DECISION OF THE SALEM PLANNING COMMISSION

CLASS 3 DESIGN REVIEW / CLASS 3 SITE PLAN REVIEW / SOUTH WATERFRONT MIXED-USE ZONE DEVELOPMENT PHASING PLAN MODIFICATION / CLASS 2 ADJUSTMENT / CLASS 2 DRIVEWAY APPROACH PERMIT CASE NO.: DR-SPR-SWMUDPP-ADJ-DAP21-01

SUMMARY: An application for a proposed new four-story mixed-use building consisting of a 72-bed post-acute rehabilitation facility and approximately 3,940 square feet of ground floor commercial space at the corner of Commercial Street SE and Front Street SE.

1 NORTH ELEVATION
SCALE: 3/32" = 1'-0"

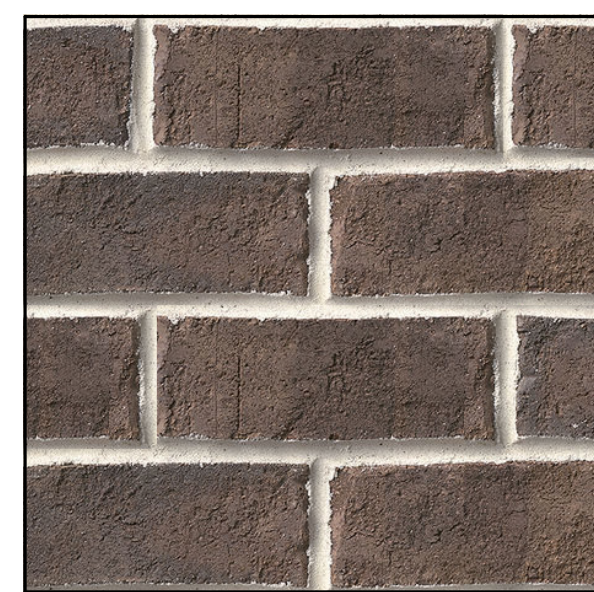
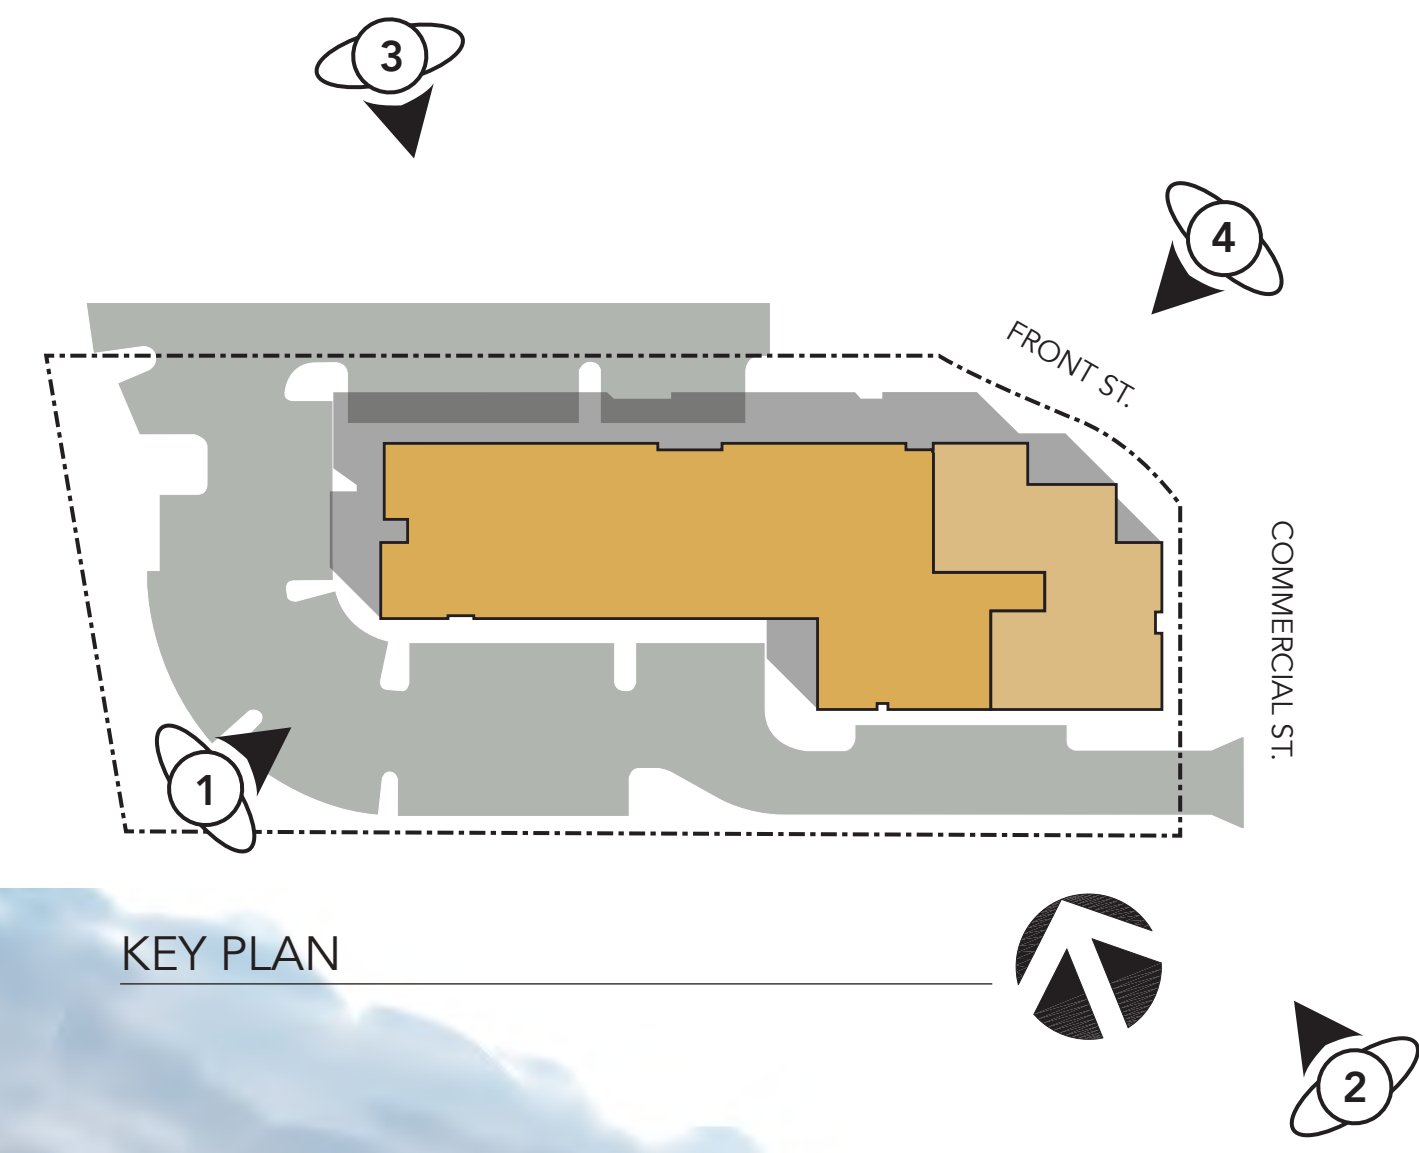
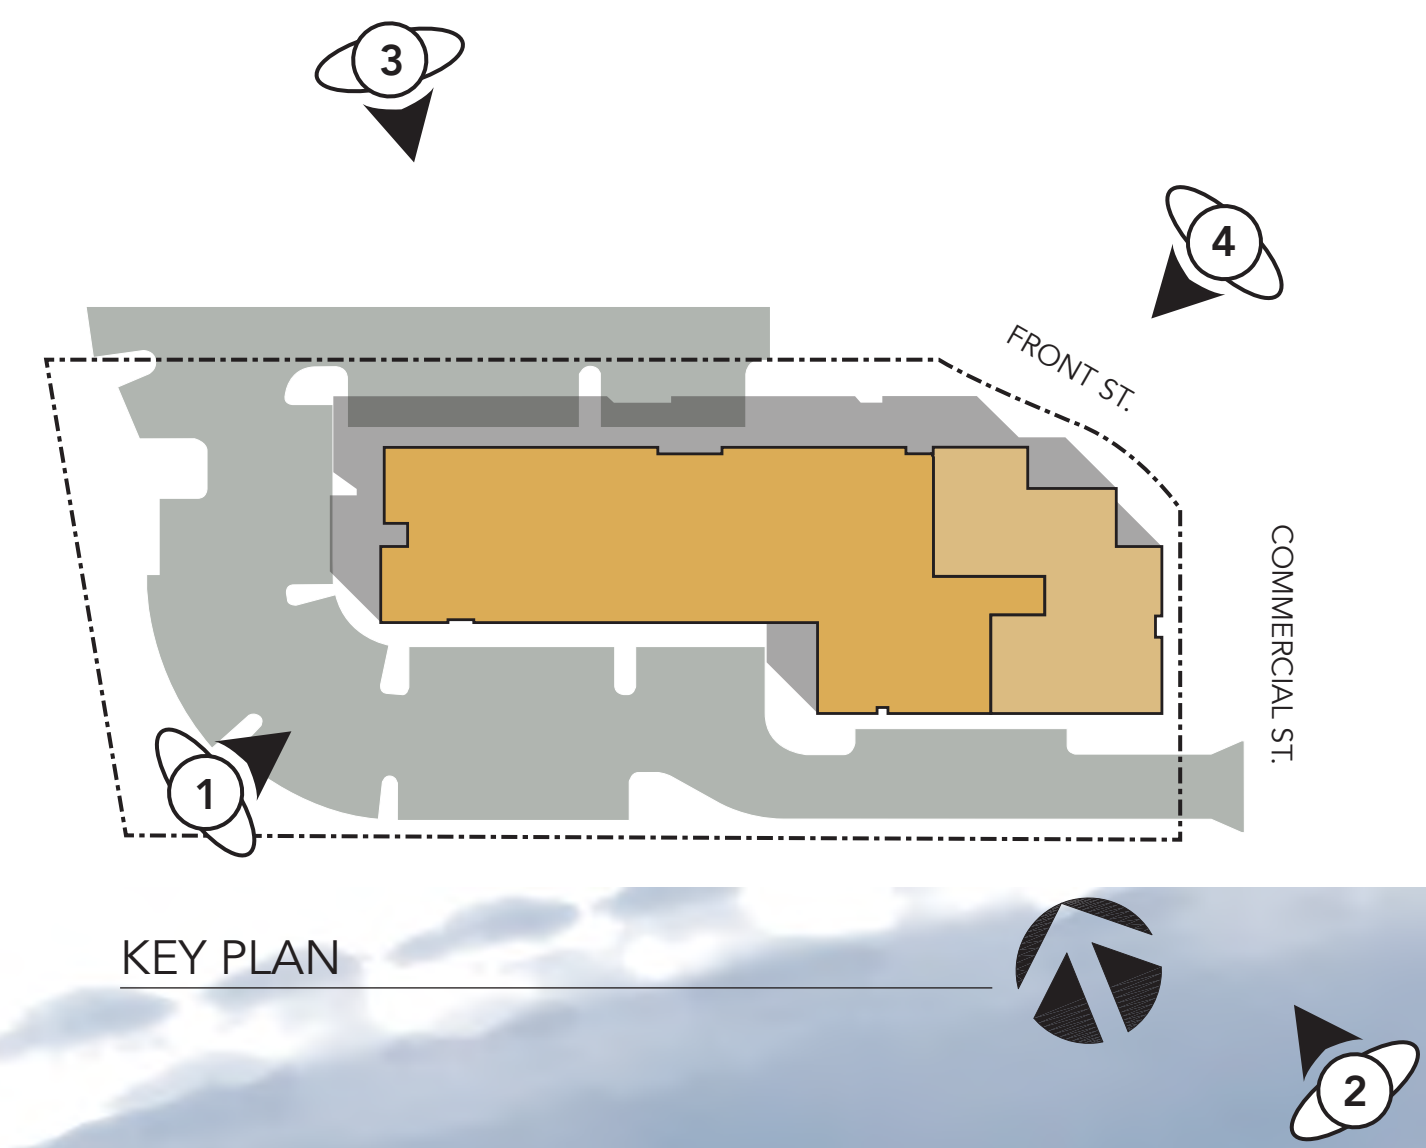
The written statement provided by the applicant (**Attachment F**) indicates that the development site contains a gateway at the site’s northeast corner where Commercial street and Front Street intersect. The building design incorporates “tower” block elements to break up mass and horizontal planes. These tower blocks highlight the site’s gateway corner and street presence through the use of contrasting color, façade materials and architectural details especially for those portions of the building that contain retail commercial uses on the ground floor. A plaza and landscaping is located at this corner promoting interaction between the public right-of-way and the development highlighting the ground floor tenant spaces, therefore meeting guidelines (aa) and (cc) as needed.

Condition 2: *The design of the building adjacent to the corner of Commercial Street SE and Front Street SE shall be revised to incorporate additional architectural detailing, such as a projecting roof, increased building height or massing, or special window treatments, to visually emphasize the corner of the building.*

Upon consideration of the above recommended condition and the arguments in support of the condition raised by staff and the objections to the condition raised by the applicant, the Planning Commission found that the condition was unnecessary due to the applicable design review guideline requiring that only one of the architectural/site planning techniques identified need be employed to visually emphasize the corner of the building at this location. As such, the Planning Commission voted to remove Condition 2 of the design review approval and found that, as indicated in the applicant's written statement and testified at the public hearing, the proposal includes a plaza and landscaping in conformance with SRC 531.035(d)(1)(A)(i)(cc), which requires public gathering spaces, such as plazas, located at the corner that incorporate special paving materials, site furnishings, and/or landscaping treatments.

Because the proposal incorporates one of the architectural/site planning techniques identified under 531.035(d)(1)(A)(i), the proposed development conforms to this design guideline.
